RE: FEMA California Coastal Analysis and Mapping Project / Bay Area Coastal Study

SUBJECT: Response to Comments Received on the San Mateo County Draft Work Maps

**San Francisco Bay Area Coastal Study
San Mateo County
Flood Risk Review Response to Comments**

San Mateo County: Comment 1

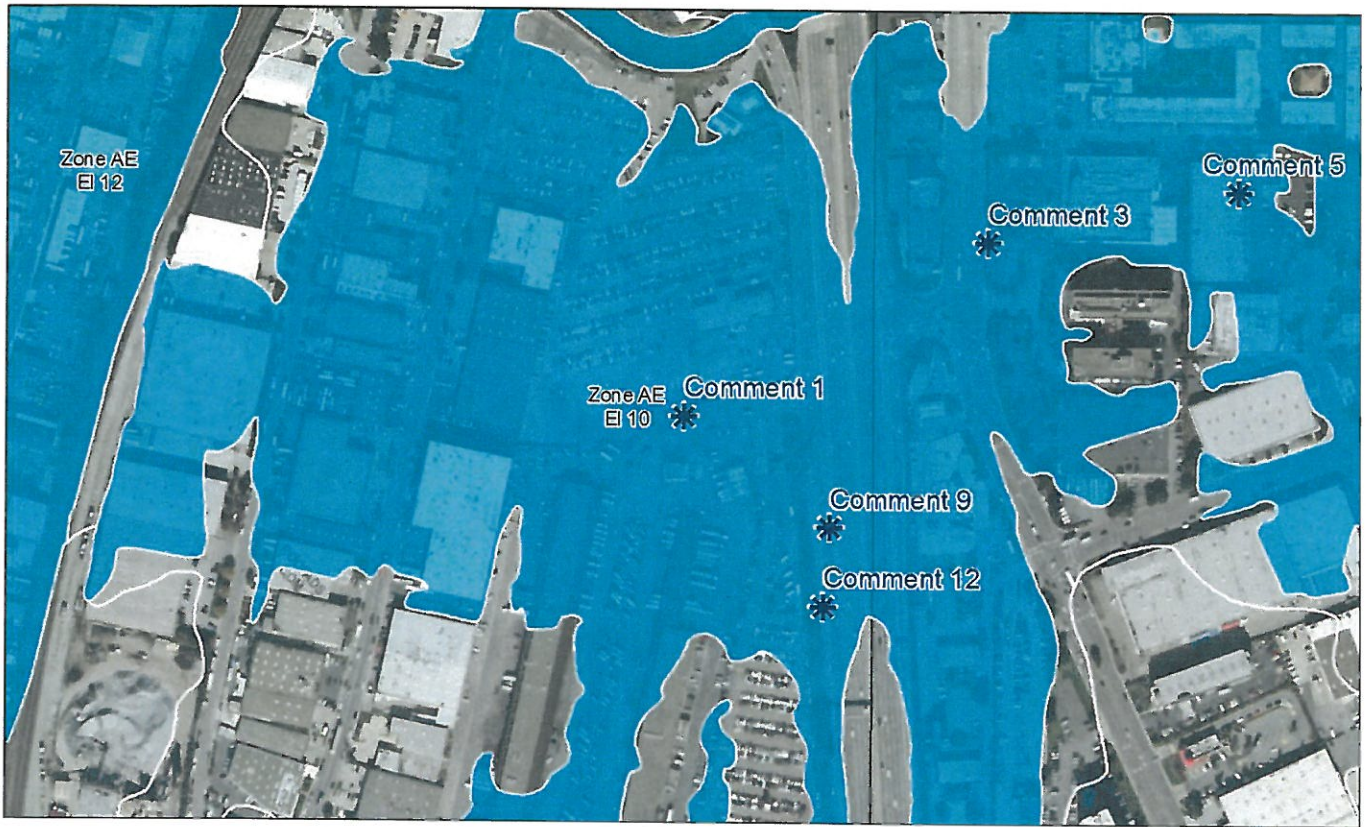
San Mateo County Response to Comments				
Comment ID	X	Y	Comment	Response
1	-13626368.4	4529544.4	Are rounded base flood elevations used to map the extents of the Special Flood Hazard Areas, or is a rounded BFE listed, but the precise elevation from the study reports used to map the extents of one-percent flooding? The extents of the flooding does not seem to match the listed base flood elevation but are more extensive. If the precise elevation is used, and since there are slight variations in the one-percent SWEL, how are the interior limits of inundation determined?	The Base Flood Elevation (BFE) label on the FIRM is rounded to the nearest whole-foot, but the boundary is mapped using precision to the tenth of a foot, and the tenth of a foot BFE will be presented within the Flood Insurance Study. The inundation limits are mapped using the 1% Still Water Elevation (SWEL) from the nearest transect(s).

San Mateo County: Comment 2

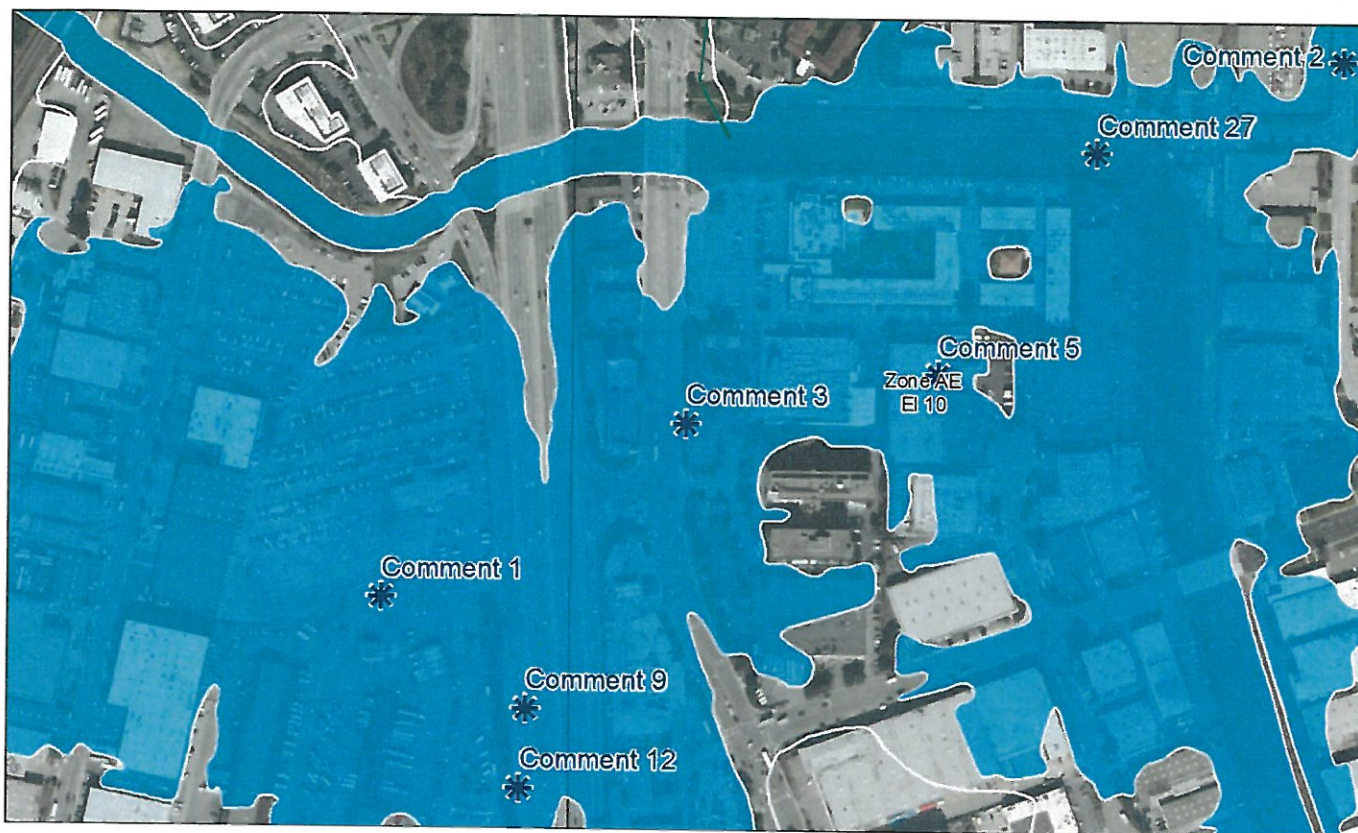
2	-13625519.6	4530031.6	It appears that the new coastal hazard mapping ties into interior flood hazard delineation based on the September 9, 2013 LOMR. Please confirm. Does the revised coastal hazard study affect riverine flooding (e.g. Colma Creek), and how have the new coastal hazard maps been conformed to previously completed flood hazard mapping?	Yes, the Letter of Map Revision (LOMR) Case no. 13-09-1038P was partially incorporated into this physical map revision (PMR). The new coastal information supersedes the flood hazard information in the LOMR up to the railroad crossing between San Mateo Ave and South Linden Ave. Upstream of the railroad crossing the LOMR has been incorporated into this PMR. The floodplain areas associated with the LOMR are coded "LOMC16" in the SOURCE_CIT attribute of the mapping database layers. Additional information on this mapping decision is documented in Section 2.3 Incorporation of LOMCs of the Floodplain Mapping TSDN report. This report can be provided upon request. The revised coastal study does not affect the Colma Creek floodplain upstream of the coastal flood hazard areas.

San Mateo County: Comment 8

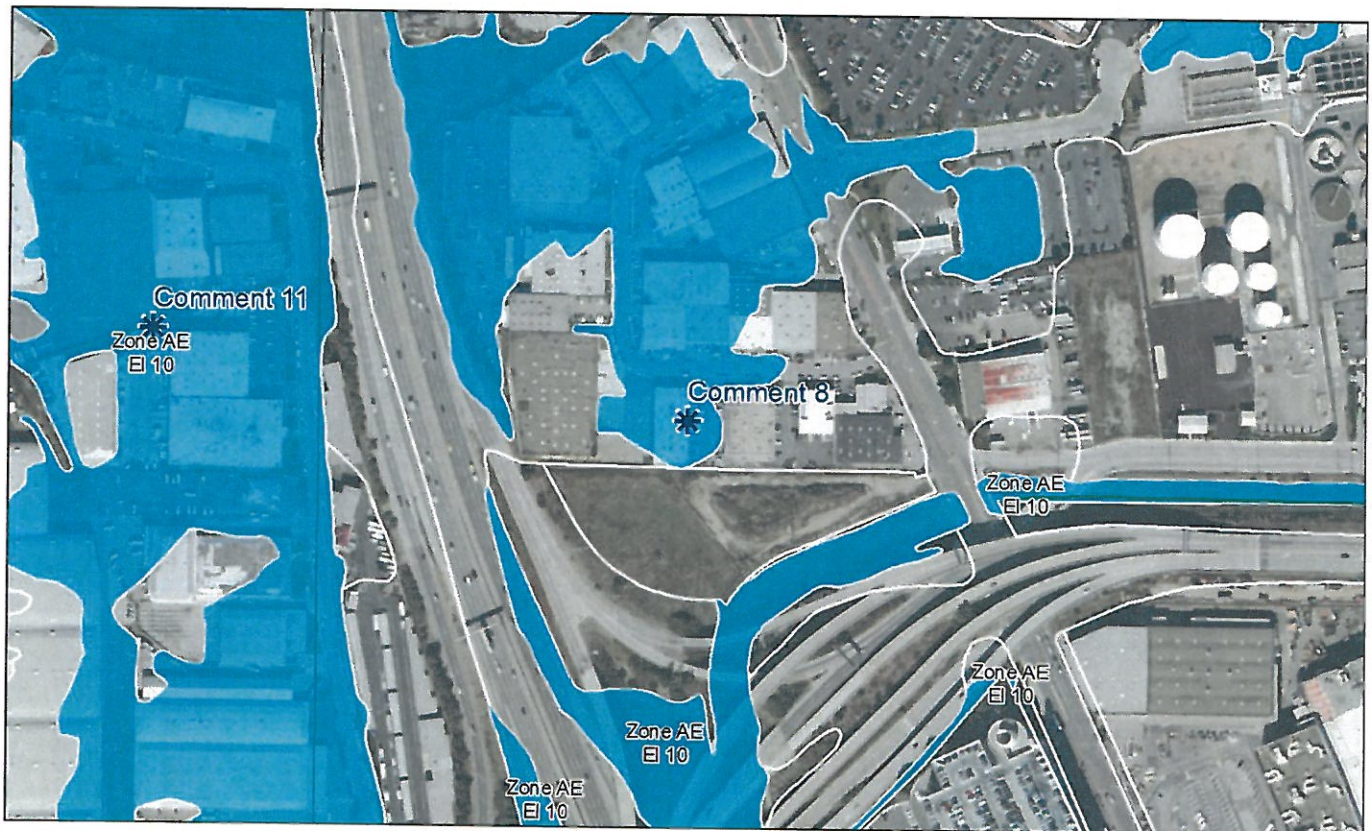
8	-13625875.0	4528604.0	Another ongoing study for San Francisco International Airport references a DHI model one-percent stillwater elevation of 10.0 feet NAVD at the north end of the airport near its treatment plant. The closest CCAMP transect to this referenced location is only 2,000 feet to the north, but the listed one-percent stillwater elevation, which should be based on the same DHI model, is 10.5 feet NAVD. While the BFE is rounded to 10 feet NAVD on the preliminary map, this seems like a real difference in DHI model interpretation.	The regional modeling of San Francisco Bay was conducted in two phases. The first phase, focused on the North and Central Bay, was completed in 2011 (DHI, 2011). The second phase, focused on the South Bay, was completed in 2013 (DHI, 2013). SFO is located at the southern limit of the North and Central Bay study. The differences in 1-percent-annual-chance stillwater elevations between the (California Coastal Analysis Mapping Project (CCAMP) study and the SFO study described in the comment is likely referring to the differences in the results from the North and Central Bay model versus the South Bay model. Section 3.2 Water Level and Wave Starting Conditions of the Coastal Analysis Report describes the technical differences between the two models in more detail. This report can be provided upon request.

San Mateo County: Comment 9

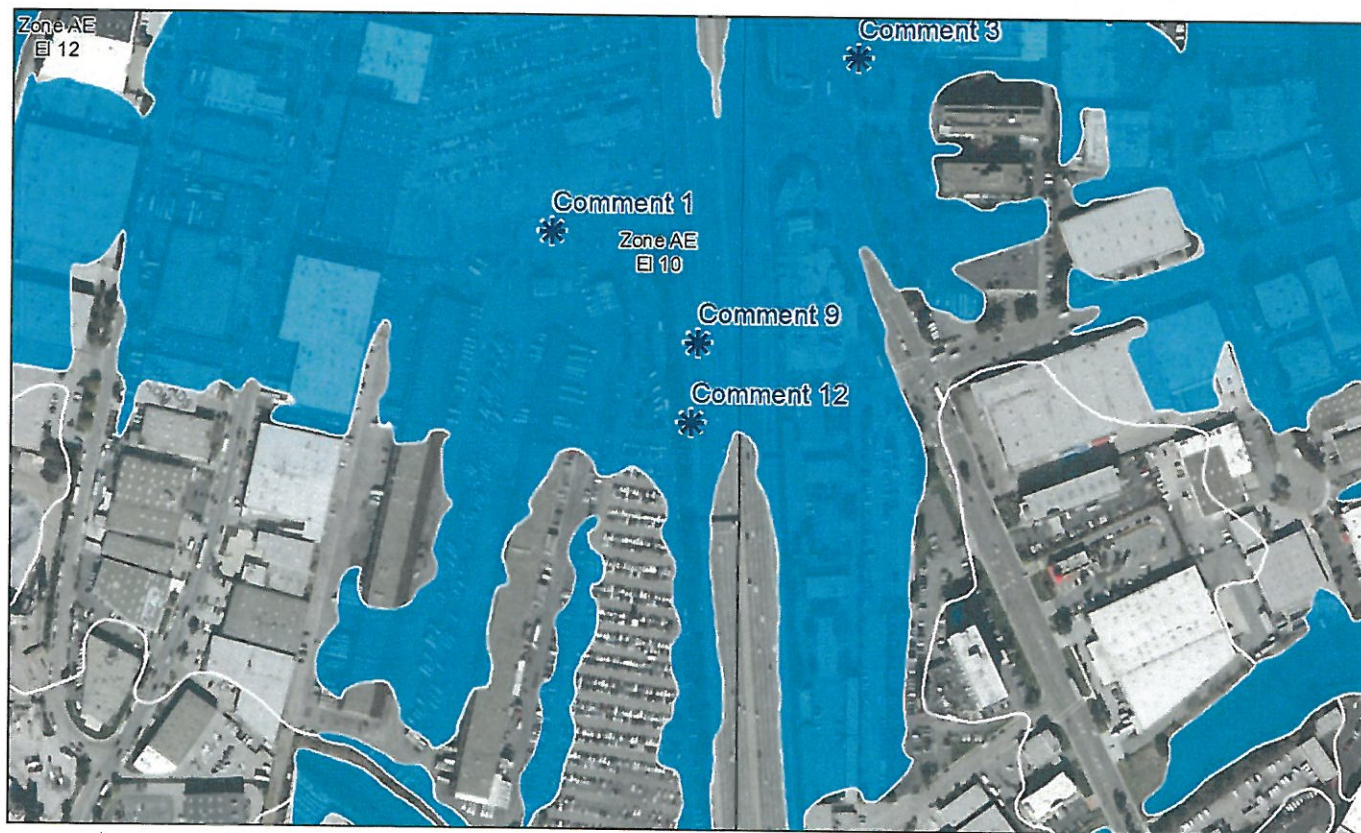
9	-13626239.3	4529446.6	The area of flooding seems to assume an infinite duration of SWL effect and resulting flood water volume. Peak tide period is limited in duration and would limit the amount of water and inland reach of inundation.	FEMA coastal analysis is evaluated for steady state conditions. It is acknowledged that there are a lot of underlying assumptions and caveats with such an approach; however, extending the analysis to a more sophisticated approach (such as including 2D overland flow) would also require many underlying assumptions and caveats. It should be noted that a higher degree of precision in the modeling does not necessarily mean the answer is more accurate. There are multiple channels, creeks and low spots were the 1% annual chance flood can be routed from the Bay to these locations; therefore they are mapped within the Special Flood Hazard Area (SFHA), area inundated by 1% annual chance flood event.

San Mateo County: Comment 13

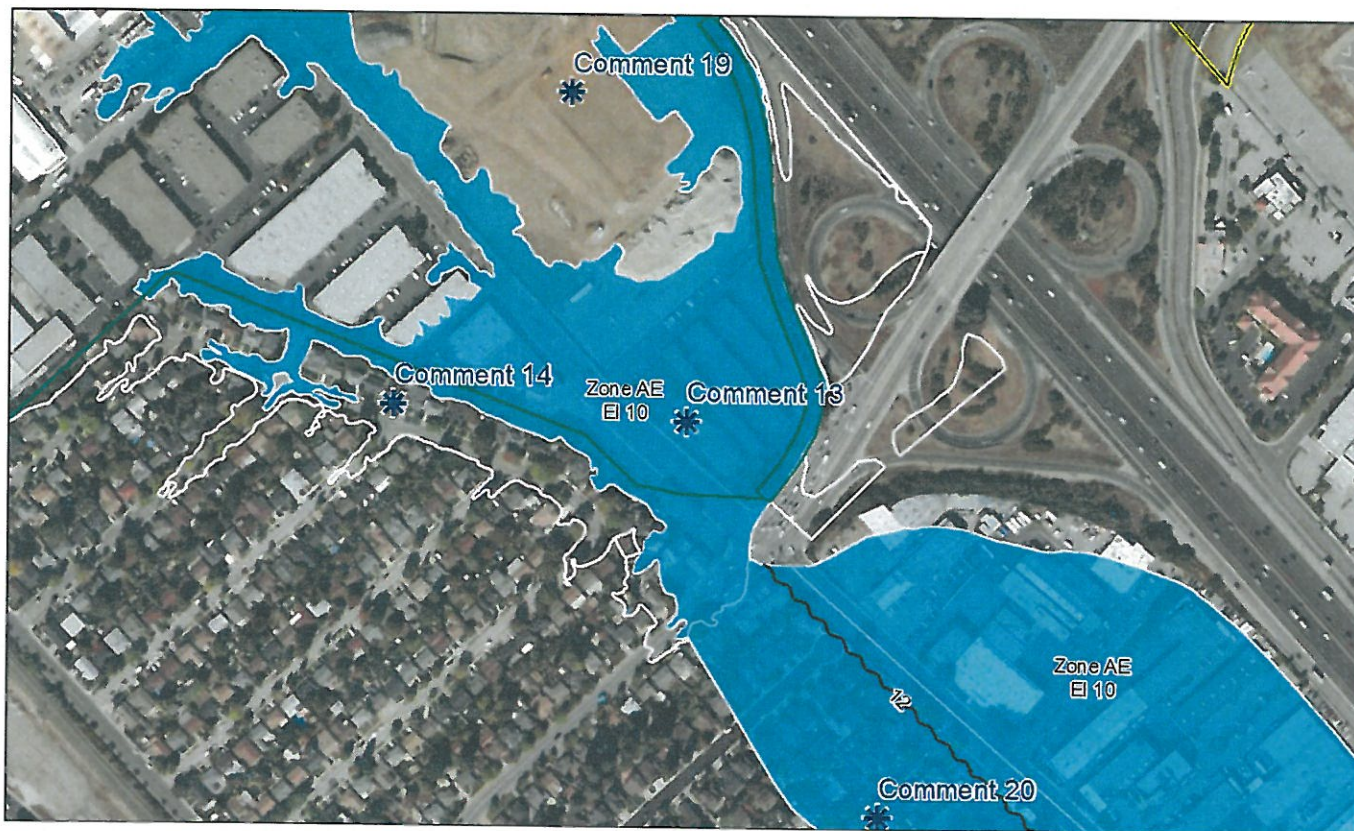
13	-13609749.8	4510816.9	The parcel for In & Out Burger should have the restaurant structure removed from the Zone AE Flood Hazard Area as it was built at or above BFE.	If this structure is associated with an existing Letter of Map Amendment Application (LOMA), it will be evaluated for possible revalidation during preliminary map production. Based on our review, the approximate lowest elevation adjacent to this structure is 9.6 feet NAVD88. Note that this elevation is based on the 2010 NOAA LIDAR, and improvements were made after 2010, these improvements may not be represented accurately. If this structure has a lowest adjacent grade at or above the BFE, they can submit a LOMA application (including certified LAG information) to be evaluated for removal from the SFHA.
14	-13610008.5	4510830.0	Please provide complete list of addresses that are to be removed from the Special Flood Hazard Area(s).	FEMA does not complete parcel level analysis to review the individual structures that are being removed or added to the SFHA. The GIS data associated with the draft floodplain mapping can be made available to the City of San Carlos so that this assessment can be completed. When the preliminary FIRMs are released, the GIS data will be available on the FEMA Map Services Center. This data can be downloaded and reviewed when it becomes available.

San Mateo County: Comment 41

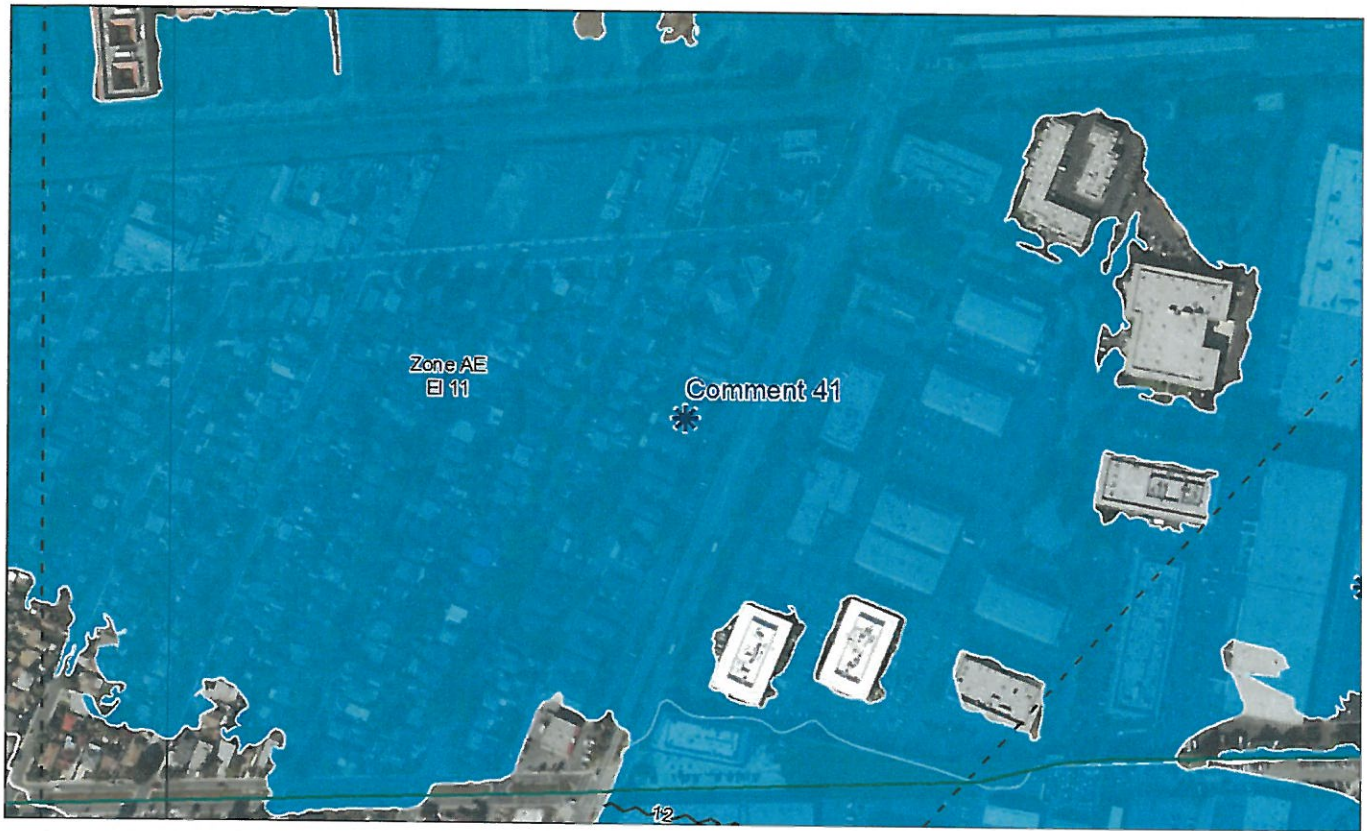
41	-13597916.0	4506009.5	In 1994 the City of Menlo Park installed a floodwall and floodgate to remove 1317-1385 Willow Road from the Special Flood Hazard Area (SFHA). FEMA granted a LOMR on 8/19/1996, Case No.: 96-09-945P, a copy of which will be emailed to you. The area upland from this location is now proposed for removal from the SFHA which indicates even less flood risk to the property. City believes this block should remain outside the Special Flood Hazard Area.	The BAC Coastal Study coastal analysis and terrain data (the 2010 LiDAR data) supersedes this LOMR. The ground elevation from the 2010 LiDAR data is below the coastal stillwater level of 10.8. FEMA accreditation data for the floodwall and floodgate have not been located by the BAC Study team. If these structures meet FEMA accreditation requirements, this information should be provided to FEMA.
42	-13596736.2	4506724.4	Please provide the City of Menlo Park with cross sections of the coastal transects 43 through 49 showing ground, shoreline, surge & wave run-up elevations.	Cross sections for these transects, with the coastal analysis representing Scenarios 1 and 2, are presented included as an attachment.
